Re: *E202122 (Roll, AZ)*

This letter is in response to requests from the Federal Communication Commission to provide supplemental information with regard to the earth station application referenced above. Specifically, the Commission requested the following information:

Figure 1: PFD Contour with county boundaries and distance/mileage scale

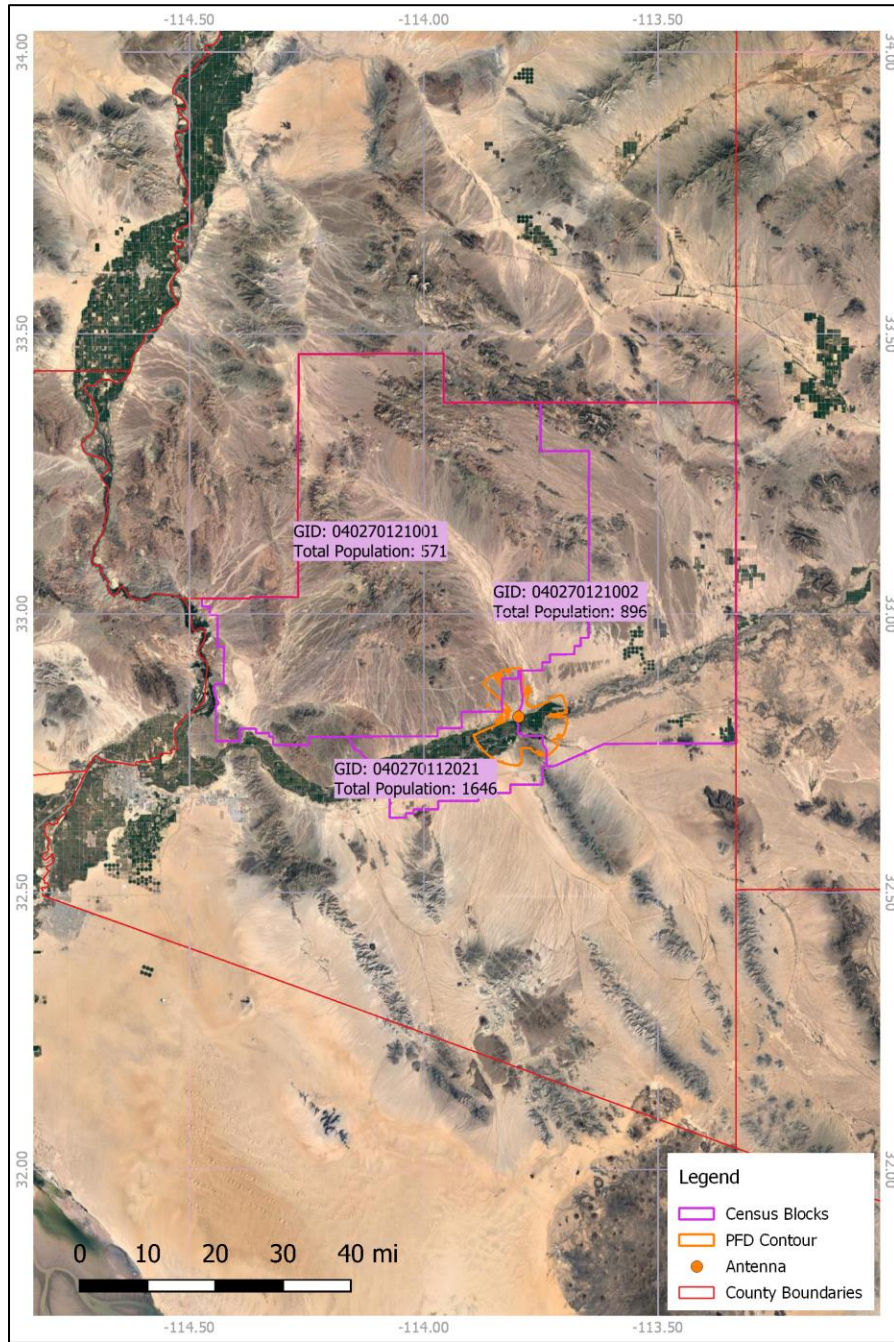
1) Addition of county boundaries and distance/mileage scale to PFD contour plots

In accordance with 47 CFR § 25.136(a)(4)(ii) and 47 CFR § 25.136(a)(4)(iii), county boundaries and map legends with distance/mileage scale for measuring the relative size of the proposed PFD contour are included as Figures 1-3 in the appendix of this document.
